RE: Eversource Energy Petition No. 1201: 1810 Line Upgrade Project
Request for Minor Project Change

1810 TRANSMISSION LINE UPGRADE PROJECT

Sheet 2

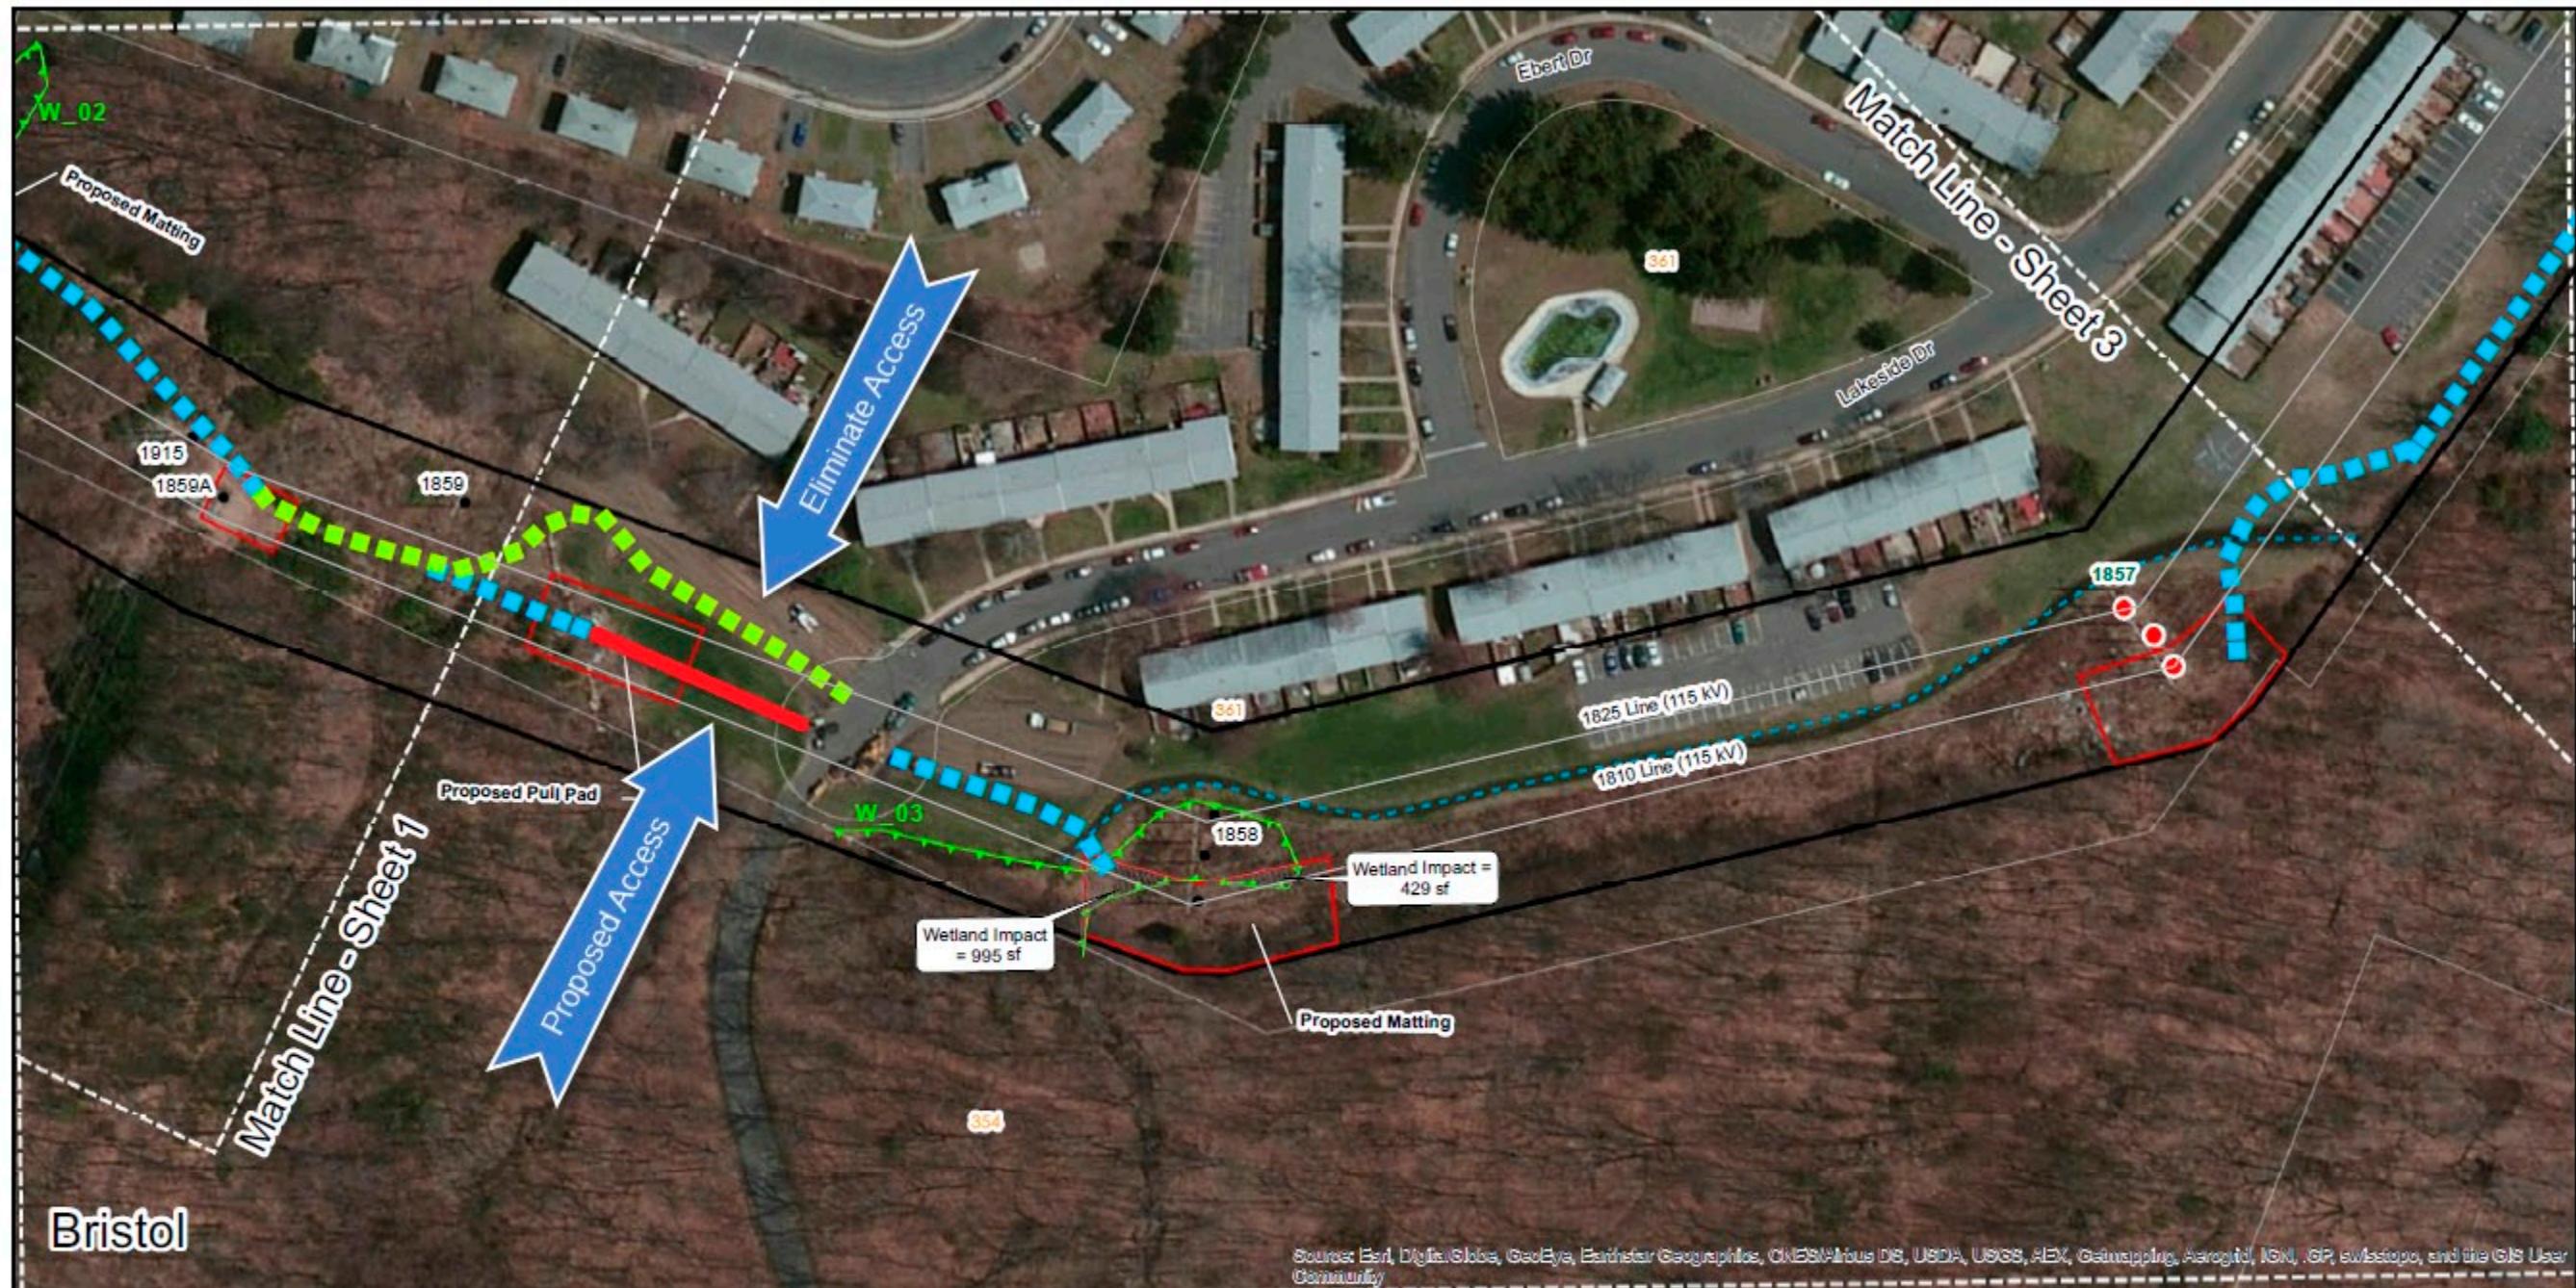
The proposed revision is to Attachment B 1810 Transmission Line Upgrade Aerial Maps, Sheet 2 (proposed revision attached). The current access off Lakeside Drive utilizes an existing road that traverses through an area utilized for additional parking by the residents of the South Mountain Condominiums. To avoid the loss of this additional parking area that would have to be vacated during active construction, Eversource proposes to revise the existing access to this portion of the right of way (ROW) by shifting the access to the middle of the ROW to the center of the proposed pull pad as shown in the attached map.

The new access would traverse over approximately 100 feet of lawn within the ROW. The road does not impact any wetlands or other sensitive resource areas. Upon completion of construction, this road would be removed and the area would be restored to pre-construction conditions. Representatives of South Mountain Condominiums are in support of this proposed revision.
